DUKE POWER COMPANY

Re: Catawba Nuclear Station
Docket Nos. 50-413 and 50-414

By letter dated September 10, 1985, Duke proposed an amendment to the Technical Specification for the reactor trip setpoint on 10-10 steam generator water level for Catawba Unit 1. This letter provides supplemental information with respect to the earlier submittal.

JUSTIFICATION AND ANALYSIS OF NO SIGNIFICANT HAZARDS CONSIDERATION

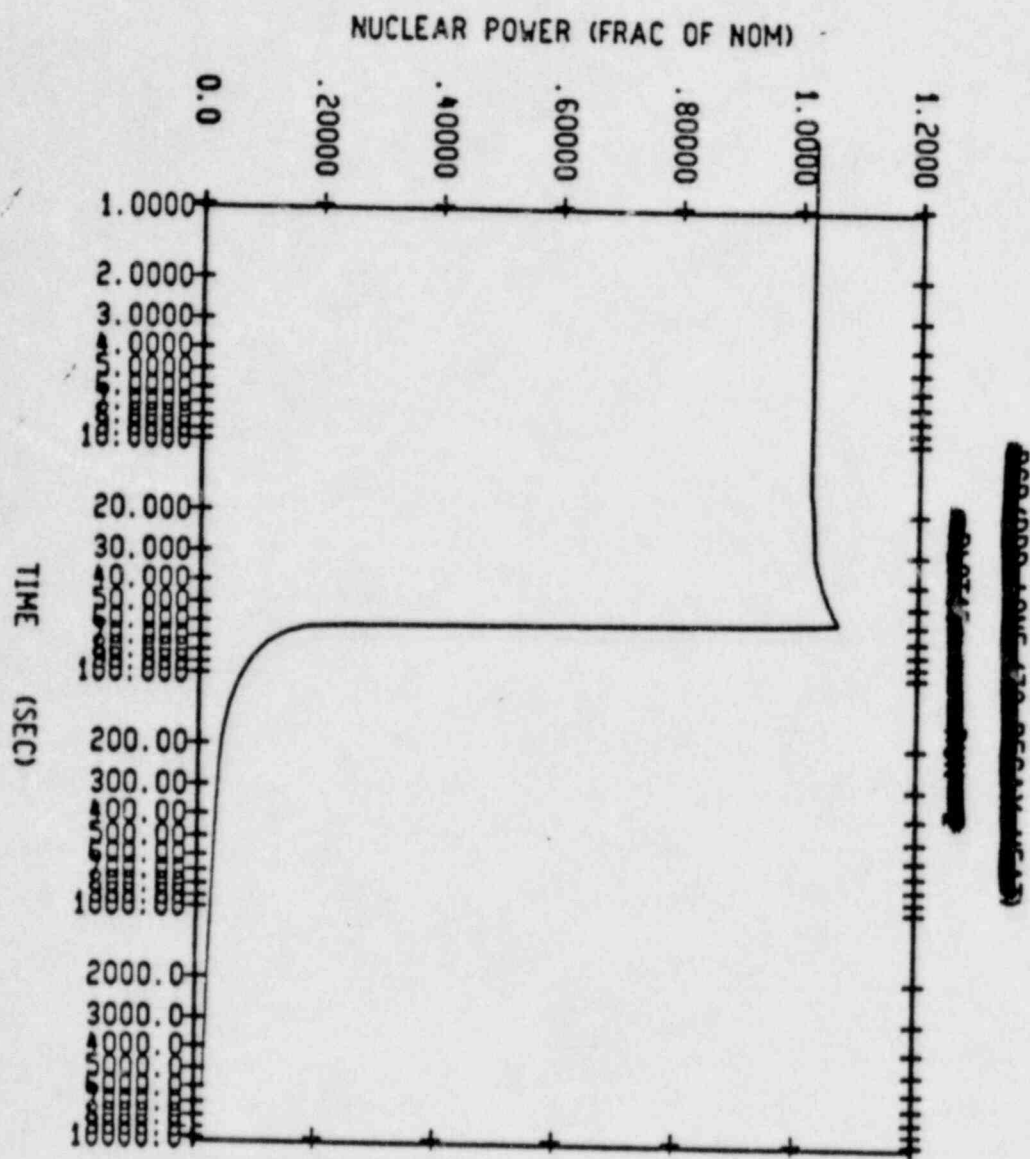
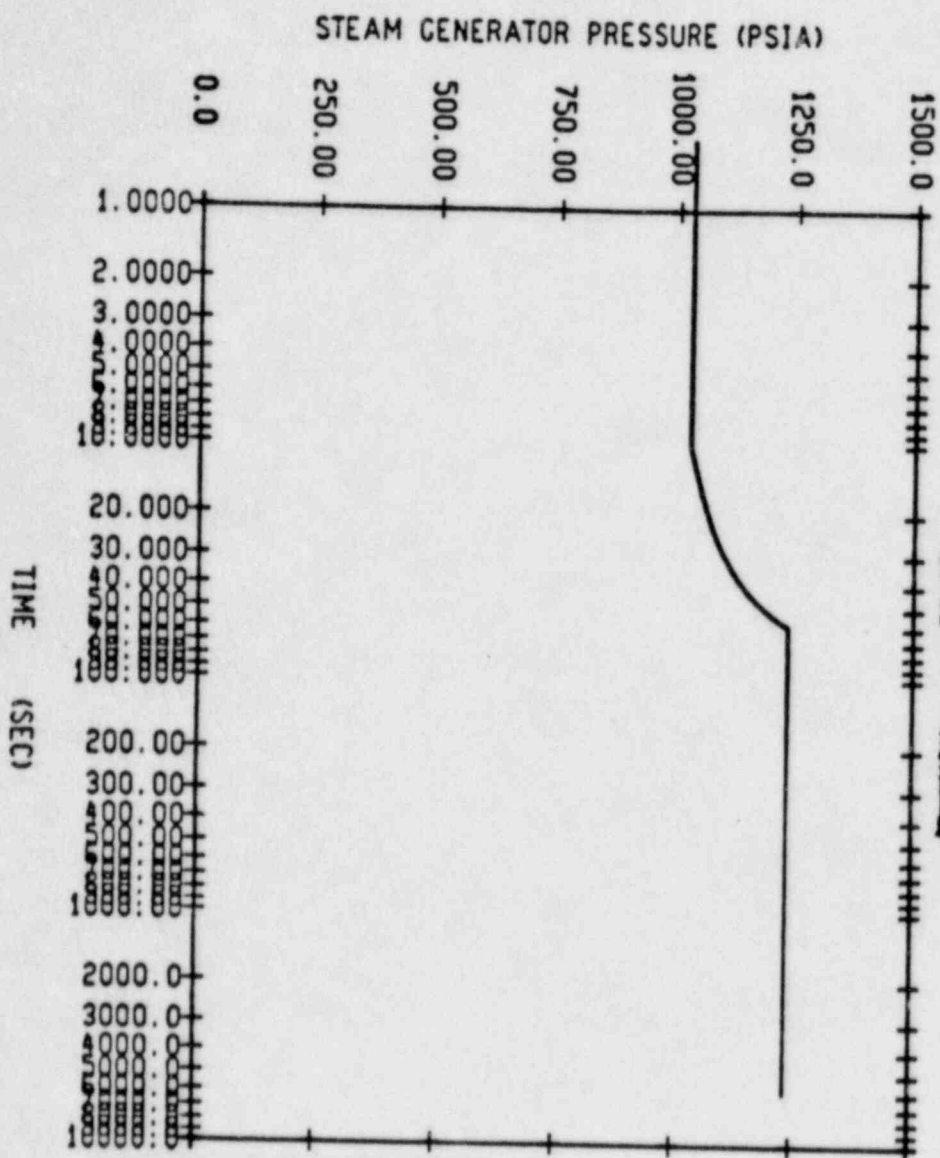
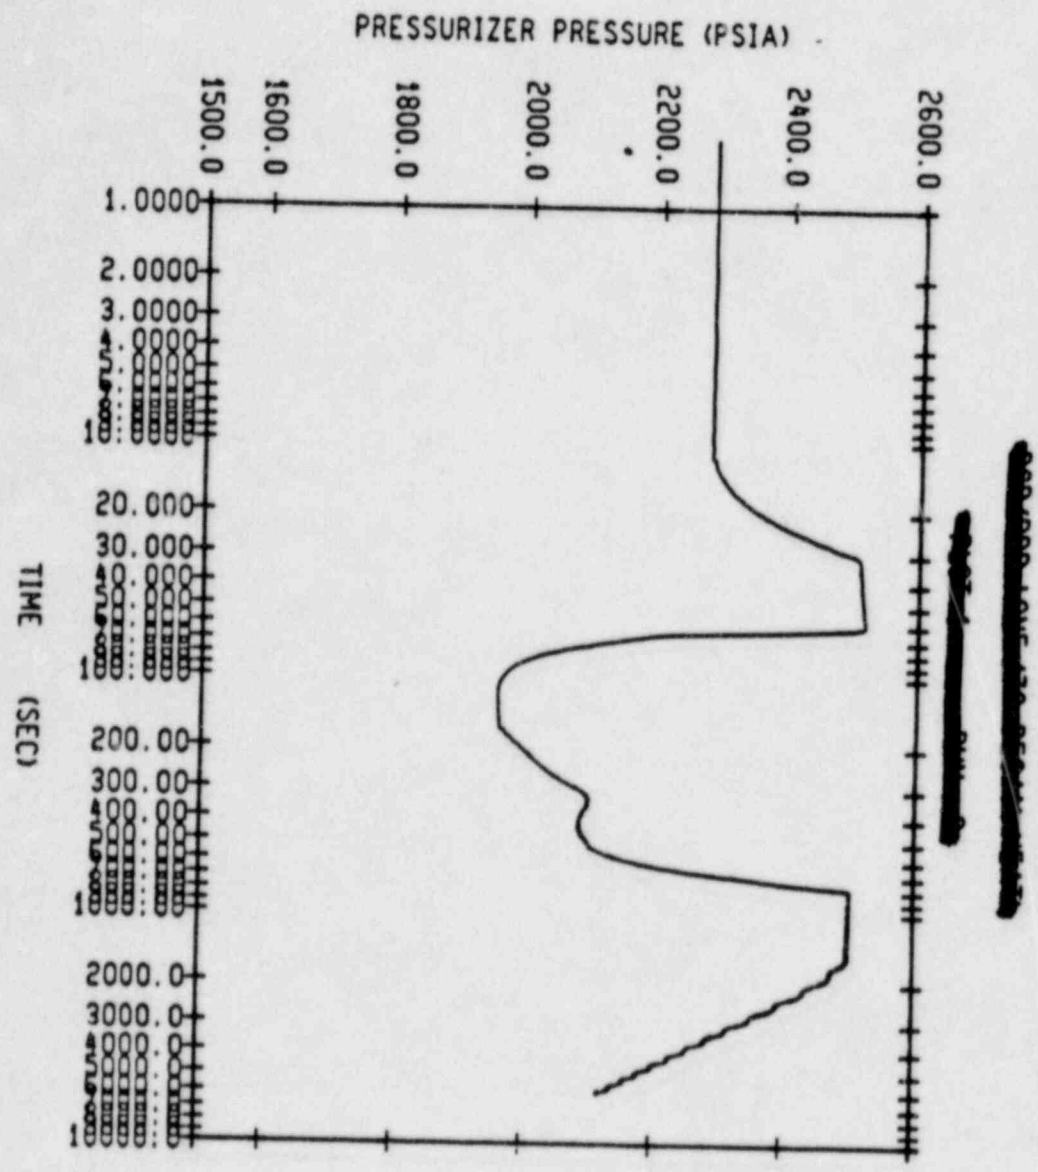
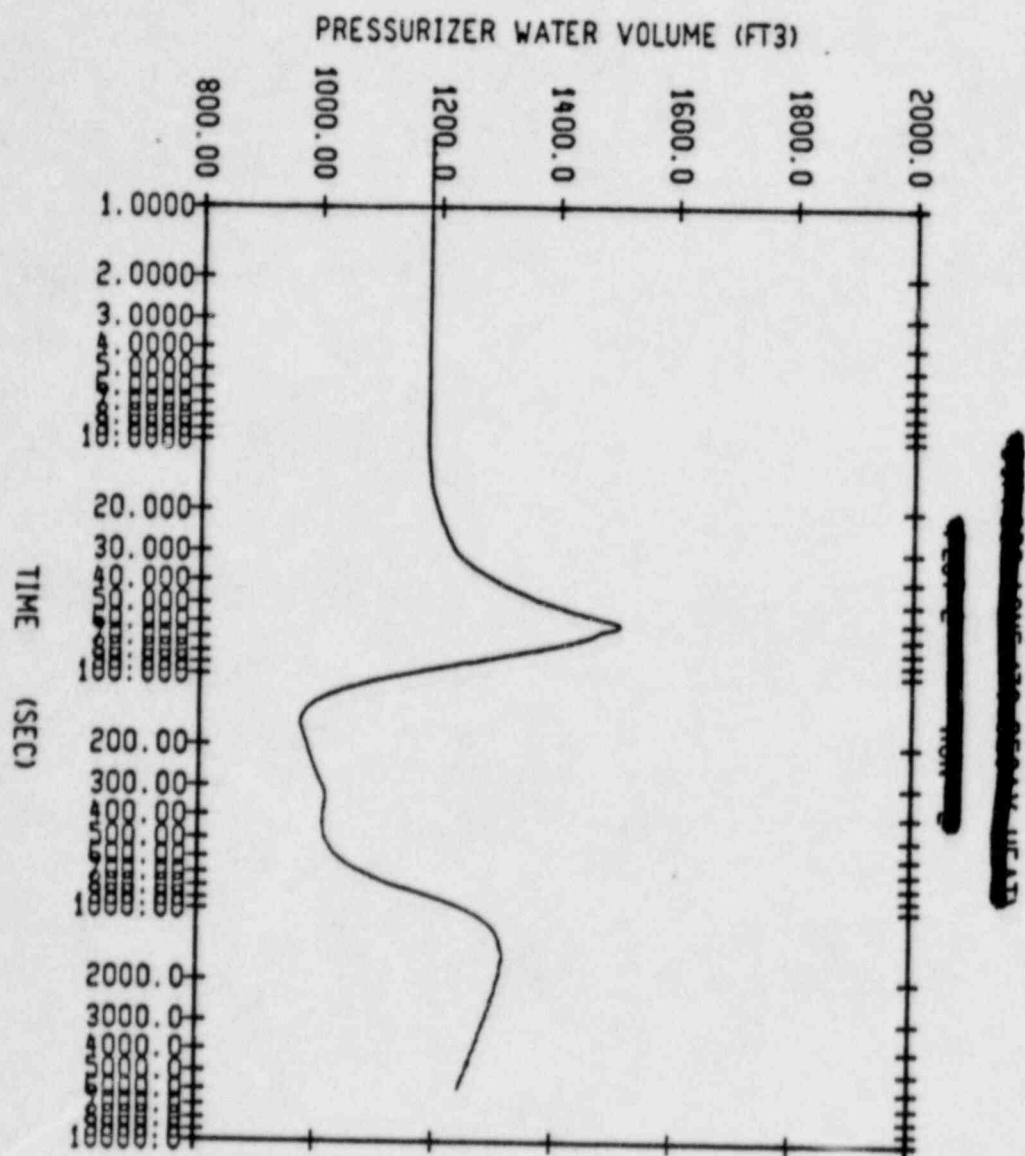
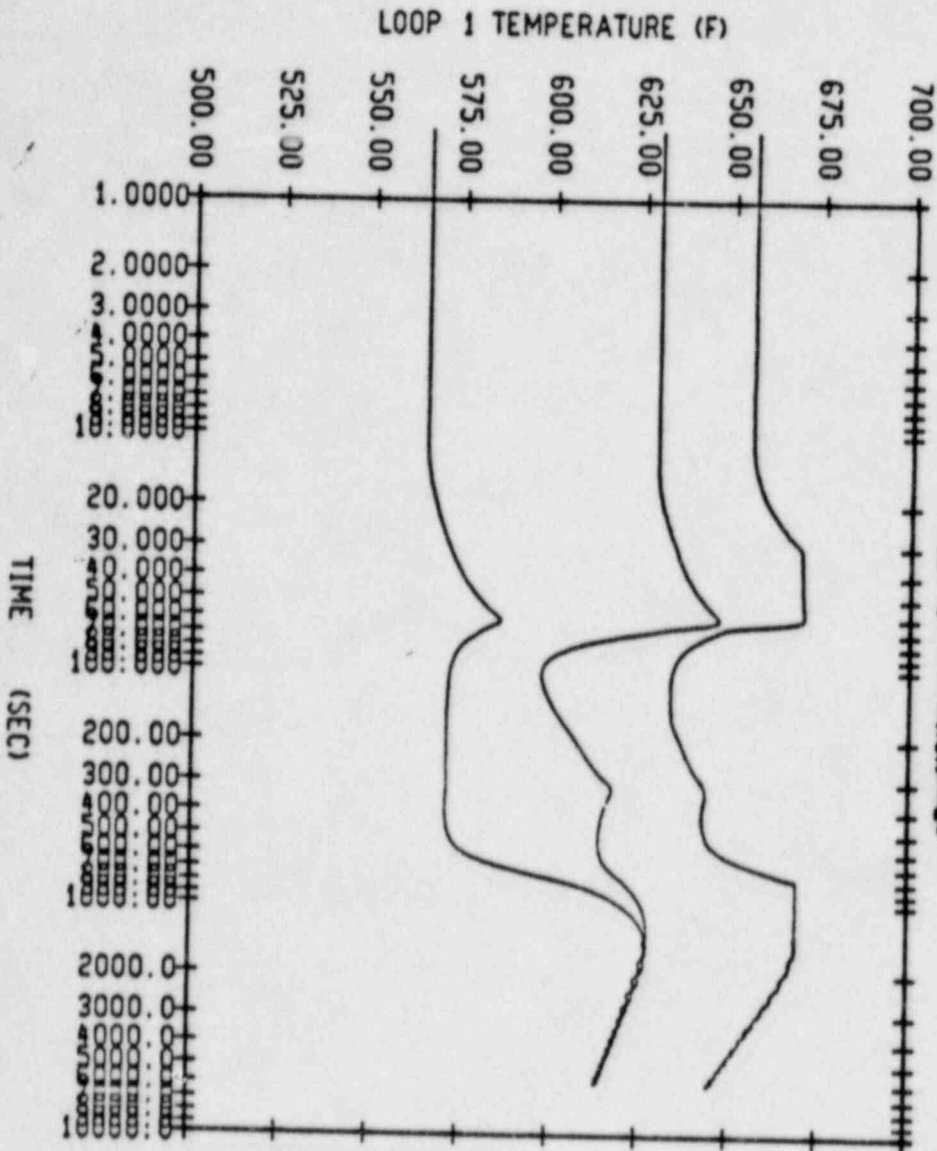
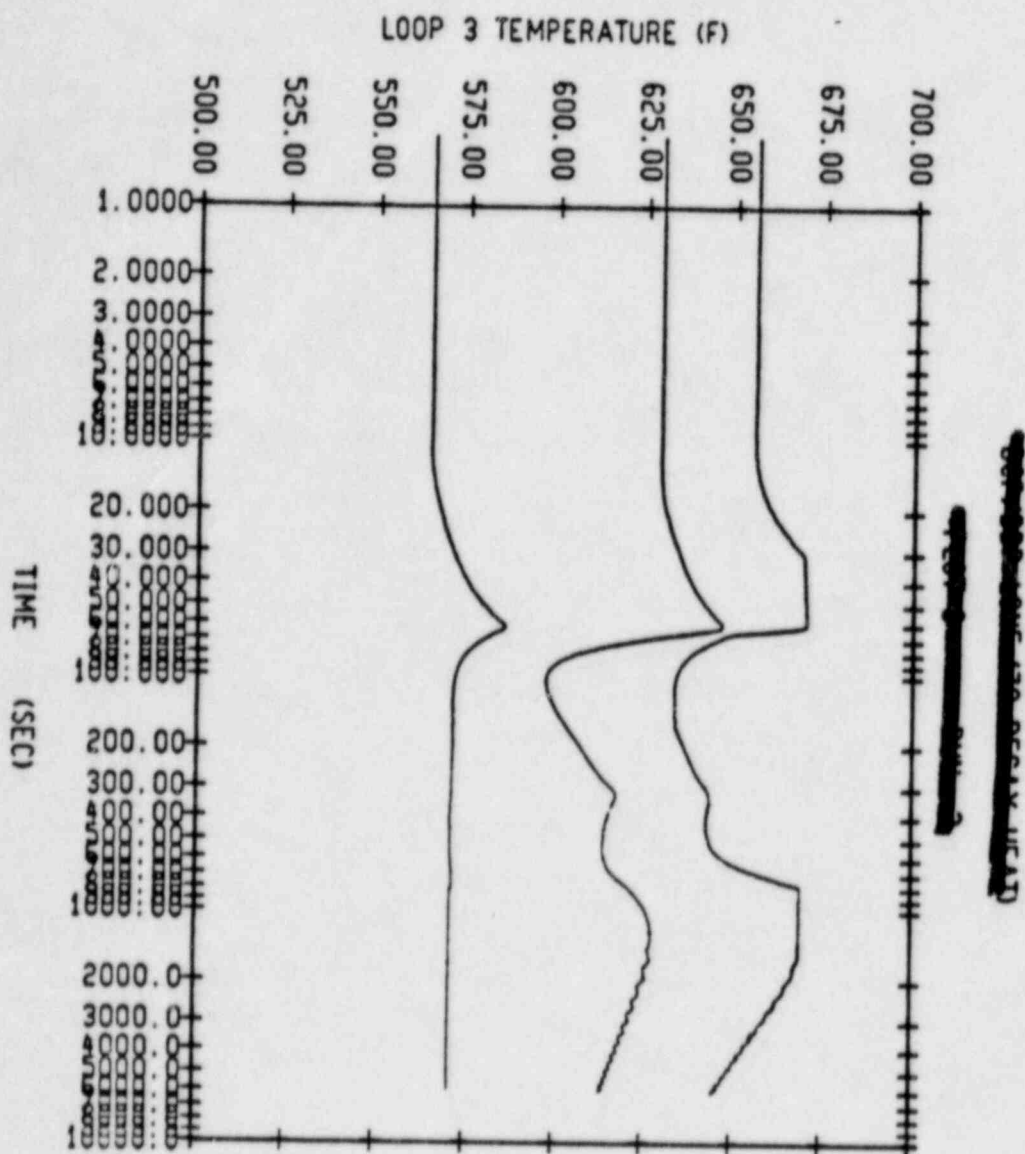
through 15.2.6-4

The transient response of the RCS following a loss of ac power is shown in Figures 15.2.6-1, 15.2.6-2, and 15.2.6-3. The calculated sequence of events for this event is listed in Table 15.2.3-1.
